# DEVELOPMENT FACILITATIVE TEAM (DFT)

**PR-2022-007805** (Second Submittal)

SI-2024-00849 – SITE PLAN DFT

**Project Name:** *Roses Southwest Papers – Crick Crossing between Watson SE and Hawking SE*

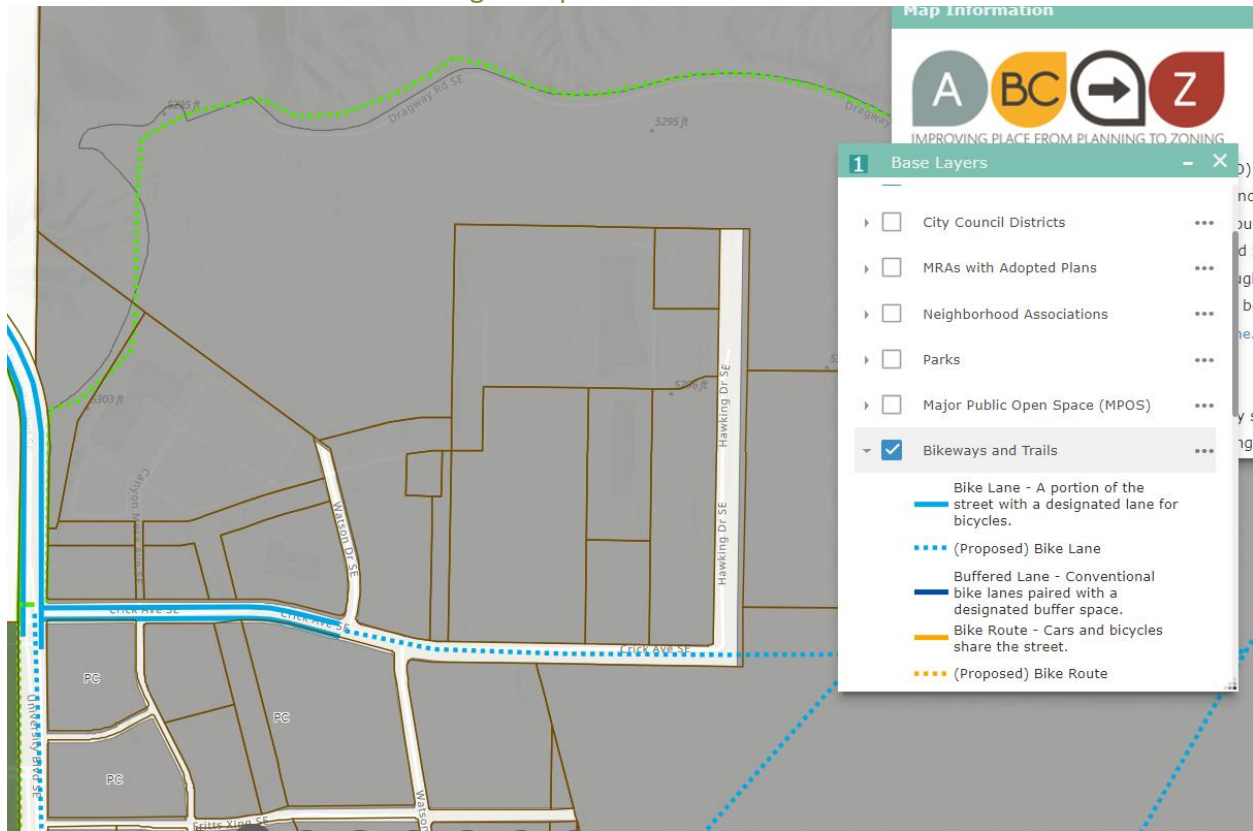
-Provide information regarding the drainage/open space/trail corridors shown on the MdS plan sheet above. How does the site drainage connect to neighboring lots? Are there opportunities to connect drainage and create open space with potential trails. **No cross lot drainage. No opportunities to share ponds.**

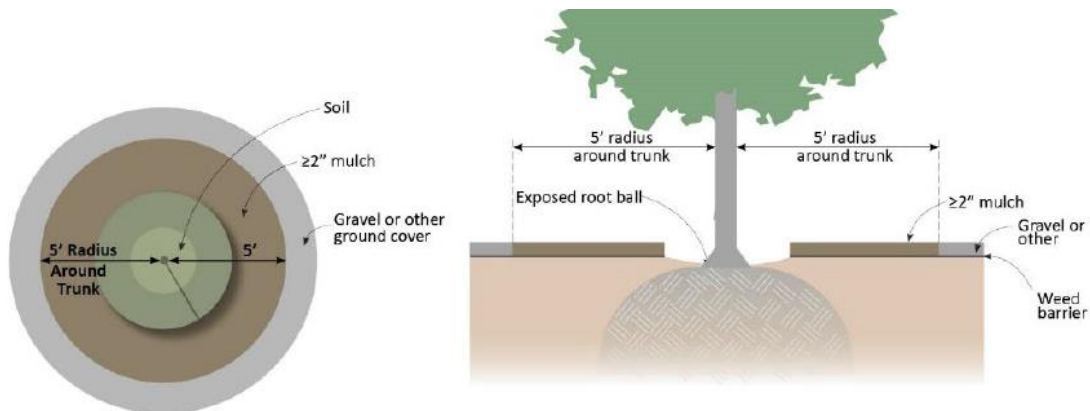
- Per 5-6(C)(5)(e) Organic mulch is required as ground cover under trees within a 5-foot radius around the tree trunk, but not directly against the trunk. In these areas, weed barrier fabric is prohibited. (See figure below.)

The tree planting detail must reflect this requirement. 5' radius must be shown on the tree

planting detail.

See revised Landscaping Sheets.
